REQUEST FOR COUNCIL ACTION

AGENDA SECTION: PUBLIC HEARINGS	ORIGINATING DEPT: PLANNING	ITEM NO. E-15
ITEM DESCRIPTION: General Development Plan #202 by Castle Court MN Limited Partnership. The applicant is proposing to re-develop the Castles Trailer Park with uses in the B-4 (General Commercial) zoning district. The property is located south of 2 nd St. SW, east of 20 th Ave. SW and north of 3 rd St. SW.		PREPARED BY: Brent Svenby, Planner
March 12, 2003		
<u>City Planning and Zoning Commission Recommendation:</u>		
<p>On February 26, 2003 the City Planning and Zoning Commission reviewed this General Development Plan. The Commission also reviewed a zone change and LUPA for the property.</p> <p>The Commission reviewed this proposal according to the criteria listed in Paragraph 61.215 of the Zoning Ordinance and Land Development Manual.</p> <p><u>Staff had recommended that the GDP be revised shifting the proposed southerly access point along 20th Avenue SW to align with one of the existing access points on the west side of 20th Ave. SW. The planning commission removed that recommendation. Staff would recommend that the Council require that that southerly proposed access point on 20th

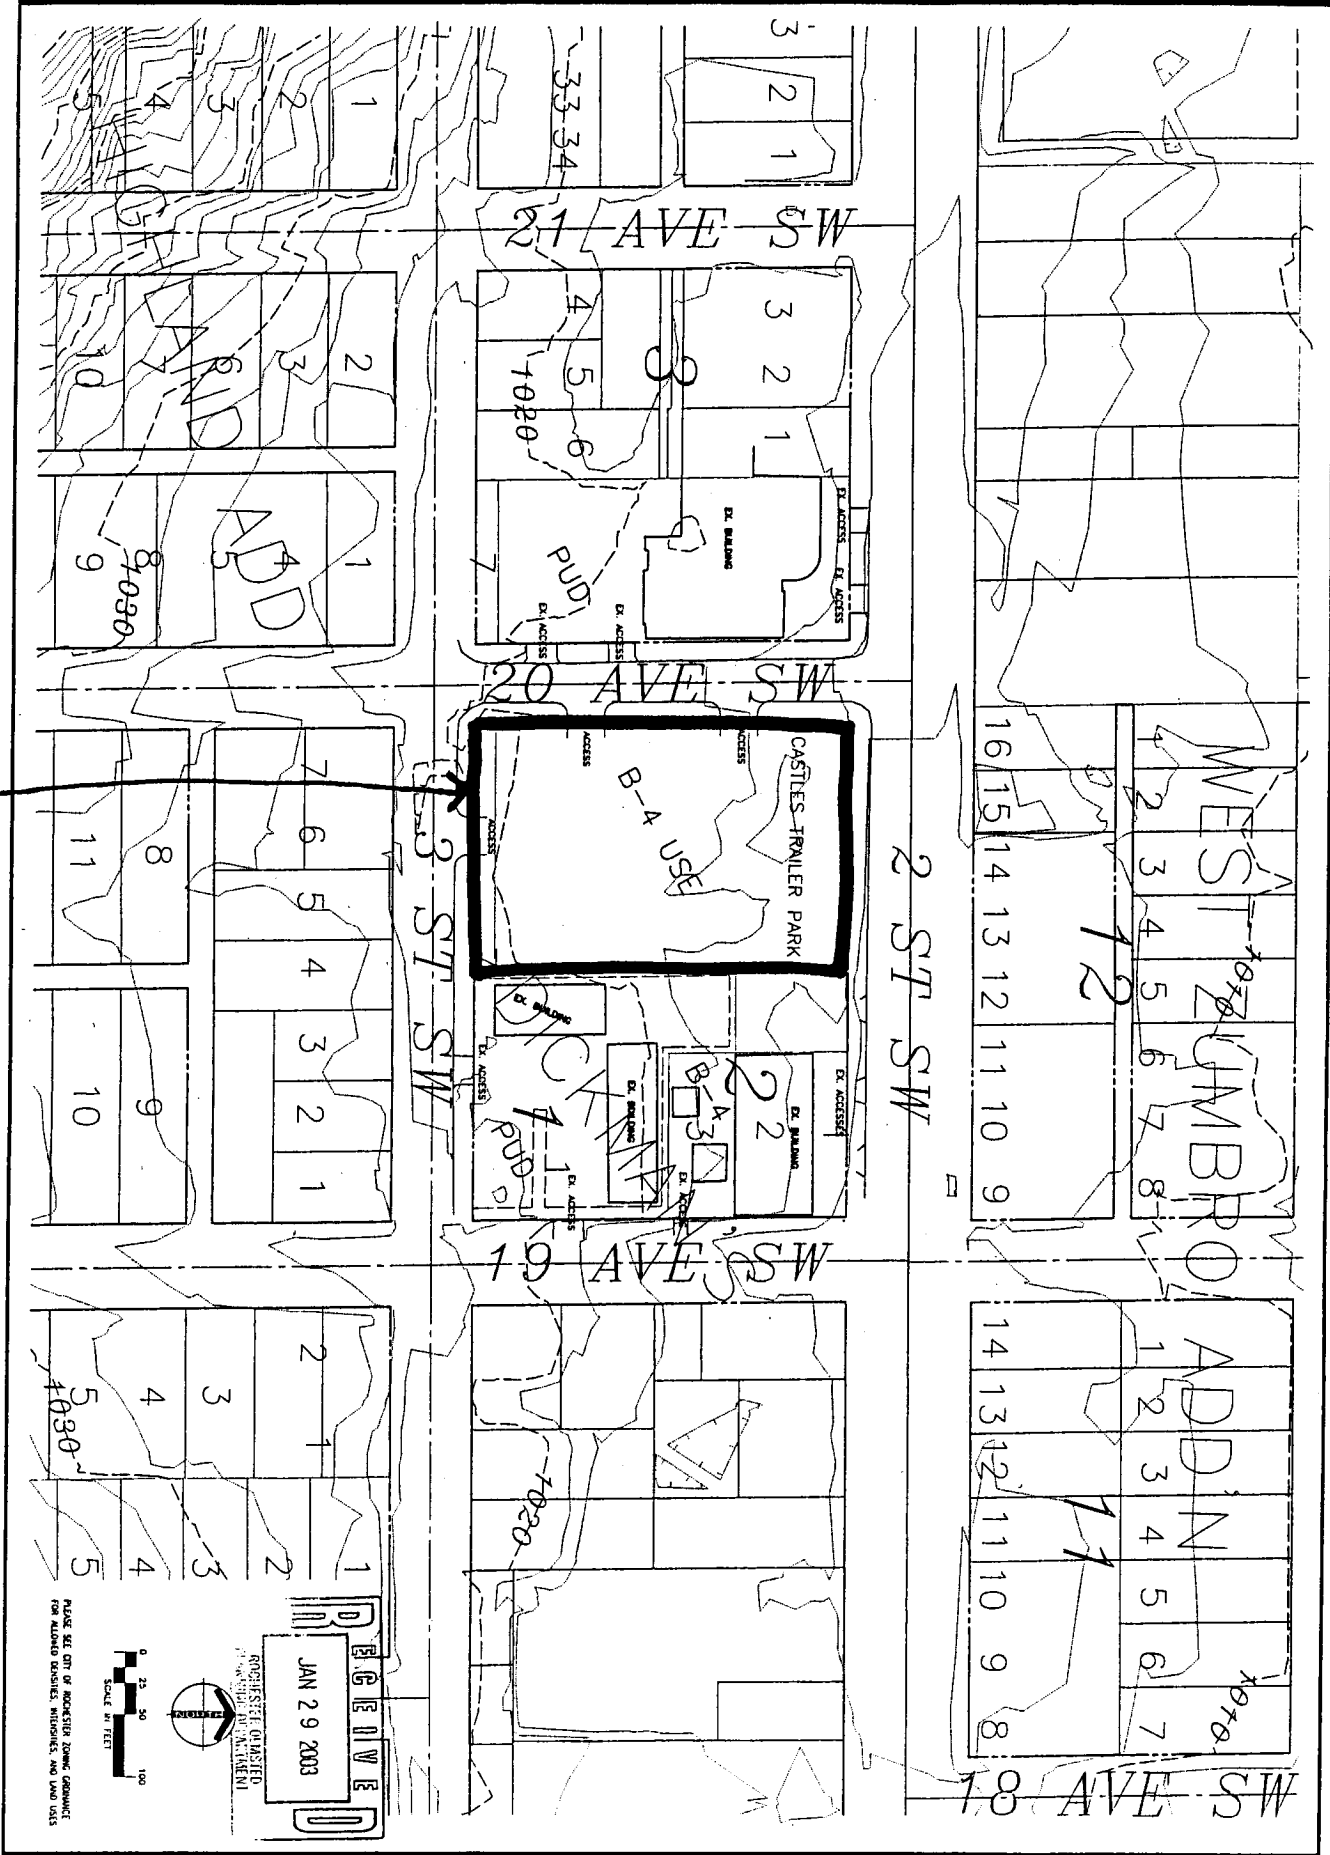
The plan proposes two access openings along 20th Ave. SW and one access opening along 3rd Street SW. The proposed southerly access on 20th Avenue SW should align across from one of the existing access locations on the property west of 20th Avenue SW. The proposed access opening onto 3rd Street SW should be removed in order to keep commercial traffic generated by the future redevelopment of the property from conflicting and disrupting the residential traffic currently on 3rd Street NW.

The plan proposes two access openings along 20th Ave. SW and one access opening along 3rd Street SW. The proposed southerly access on 20th Avenue SW should align across from one of the existing access locations on the property west of 20th Avenue SW. The purposed access opening onto 3rd Street SW should be removed in order to keep commercial traffic generated by the future redevelopment of the property from conflicting and disrupting the residential traffic currently on 3rd Street NW.

1. Grading & Drainage Plan approval is required prior to development, and a Storm Water Management charge will apply to any additional areas of impervious surface.
2. Any existing access locations that are removed for this project shall be restored with curb & gutter, sidewalk & boulevard at the Owner's expense.
3. The condition of existing pedestrian facilities along the frontages of this property will be reviewed by Public Works, and any needed panel repair or replacement work shall be done at the Owner's expense, concurrent with re-development of this Property.
4. The proposed southerly access to 20th Ave SW should align across from one of the existing access locations on the property west of 20th Ave SW.

1. ***The GDP shall be revised removing the access opening proposed on 3rd Street SW and shifting the southerly access point on 20th Ave. SW to the south to align across from the existing access location on the property across 20th Ave. SW.***

1. The GDP shall be revised removing the access opening proposed on 3rd Street SW.
2. The applicant shall receive approval of the grading and drainage plan for the property prior to the development of the site. A storm water management fee will apply to any additional areas of impervious surface from what is existing currently.
3. Any existing access locations that are removed for the redevelopment of the property shall be restored with curb and gutter, sidewalk and boulevard at the owner's expense.
4. The condition of the existing pedestrian facilities along the frontages of this property will be reviewed by Public Works, and any needed panel repair or replacement work shall be done at the owner's expense concurrent with redevelopment of this property.
